Memorandum

File No. : SB-101- 2.0/12.3
South Coast HOV Lanes
ON700

Subject : Addendum to Location Hydraulic Study

LOCATION HYDRAULIC STUDY

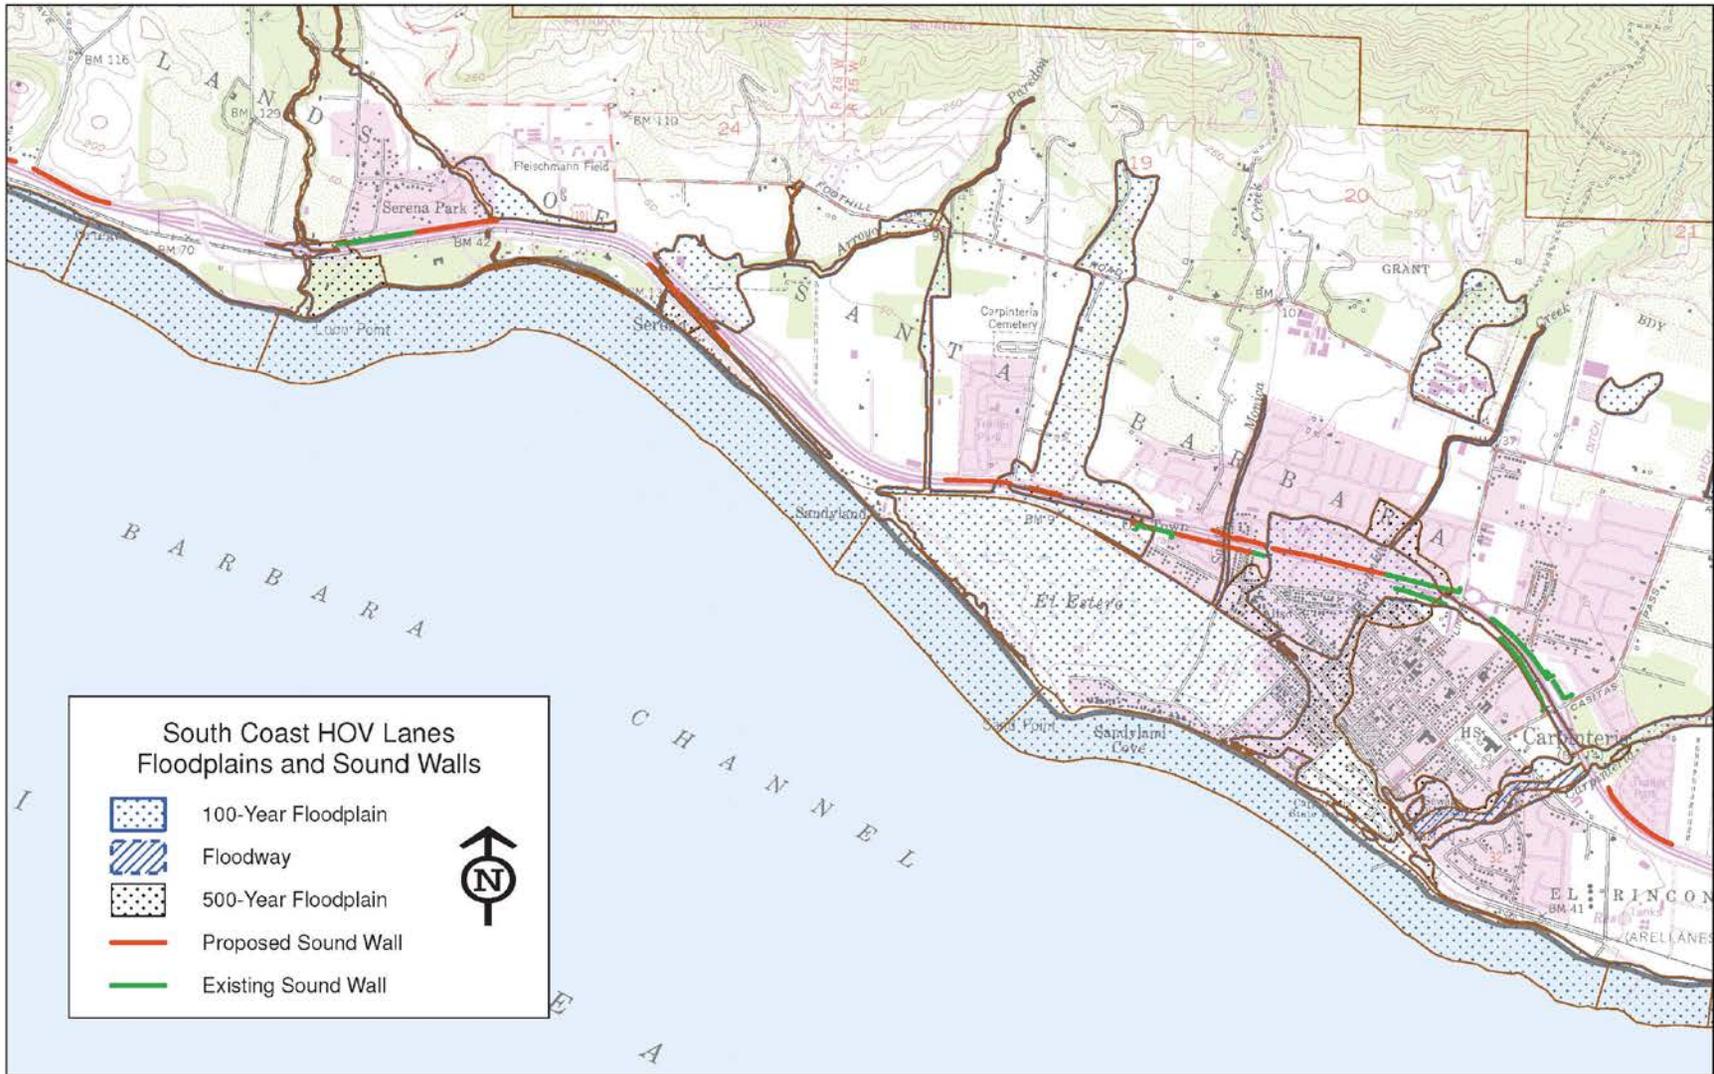
The revised FEMA FIRM modified the floodway at Romero Creek. The westerly limit of the revised floodway shifted to the east. The proposed sound wall to the west of the floodway has been extended to the revised floodway limit. The extended portion of the wall would incorporate flood gates in order to convey flood flows and would not raise base flood elevations.
